Access Compliance Report

Public Rights-of-Way

(Pedestrian Signals)

Intersection ID: N/A	Main Street:	Cross Street: N/A	Location: N/A
ADA ID: CF9154955A88	Signal Type: One Push Button-Non APS	Overall Compliance: No	Severity Score: BTN 1: N/A BTN 2: N/A No BTN: N/A
Codes/Mitigation Info/Possible Solution		Field Measurements/Component Compliance

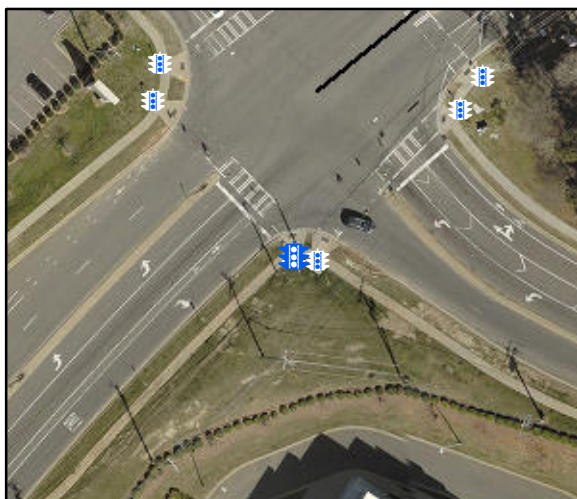
PROW/ADA: TMUTCD 4e.08, R404.2, R406.2

Yes	B 1 Clear Xing Direction?	ClearlyMarked	N/A	B 2 Clear Xing Direction?	N/A
	B 1 Crossing Direction	To NW		B 2 Crossing Direction	N/A
No	B 1 DistanceTo XWalk (in)	72.0	N/A	B 2 DistanceTo XWalk (in)	N/A
No	B 1 DistanceTo Curb (in)	181.0	N/A	B 2 DistanceTo Curb (in)	N/A
Yes	B 1 Diameter (in)	2.0	N/A	B 2 Diameter (in)	N/A

Possible Solutions: Replace Signal Push Button With APS Button on New Post. Remove & Relocate Sign.
